Access Compliance Report Public Rights-of-Way (Curb Ramps)

Main Street: DALL_LN Cross Street: CARLSBAD_DR Location: SW

ADA ID: RPAT211019111651 Ramp Type: Type 1 - Perpendicular Diagonal Initial Pass/Fail: Fail Overall Compliance: No Severity Score: 2

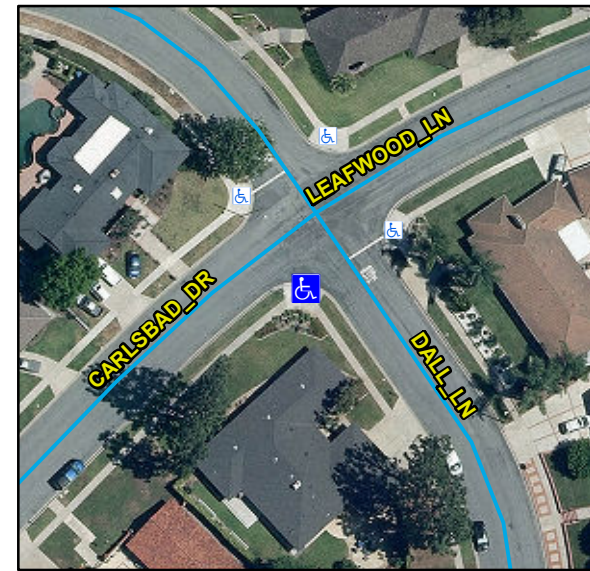
Compliance	Description	Data	Compliance	Description	Data
N/A	Ramp Length (in)	80	N/A	Flare Type LT	
Yes	Ramp Width (in)	48			N/A
Yes	Ramp Run Slope (%)	6.8	N/A	Flare Slope LT (%)	N/A
No	Ramp Cross Slope (%)	2.4	N/A	Flare Traversable LT	N/A
N/A	Landing Present	N/A	N/A	Flare Type RT	
N/A	Landing Length (in)	N/A			N/A
N/A	Landing Width (in)	N/A	N/A	Flare Slope RT (%)	N/A
N/A	Landing Run Slope (%)	N/A	N/A	Flare Traversable RT	N/A
N/A	Landing Cross Slope (%)	N/A	N/A	DWS Provided	N/A
N/A	Landing Movement Obstructed?	N/A	N/A	DWS Contrast	N/A
	Landing Movement Type	N/A	N/A	DWS Length (in)	N/A
N/A	Landing Shared	N/A	N/A	DWS Full Width	N/A
N/A	Clear Space	Yes	N/A	DWS Offset Left (in)	N/A
N/A	Clear Space To Crosswalk (in)	N/A	N/A	DWS Offset Right (in)	N/A
N/A	Marked Crosswalk 1	No	N/A	Marked Crosswalk 2	No
	Crossing 1 Direction	E		Crossing 2 Direction	N
	Marked Crosswalk 1 Width (in)	N/A		Marked Crosswalk 2 Width (in)	N/A

N/A	Ramp Inside Crosswalk 1	N/A	Yes	Ramp Inside Crosswalk 2	N/A
	Crossing 1 Slope (%)	2.7		Crossing 2 Slope (%)	3.8
	Crossing 1 Cross Slope (%)	0.7		Crossing 2 Cross Slope (%)	2.1
N/A	Gutter Ponding	N/A	N/A	Curb Slope	4.9
Yes	Gutter Lip Height (in)	0		Road Run Slope (%)	0.3
N/A	Gutter Run Slope (%)	N/A		Road Cross Slope (%)	3.8
N/A	Gutter Cross Slope (%)	N/A			
Yes	Overall Surface Condition: Acceptable		No	Perp Joint Present	No
	Cross Gutter Present?	No		Spandrel Present?	No
	Replace Cross Gutter?	N/A		Replace Spandrel?	N/A

Remove & Replace Curb Ramp With Two New Directional Ramps or Equivalent.
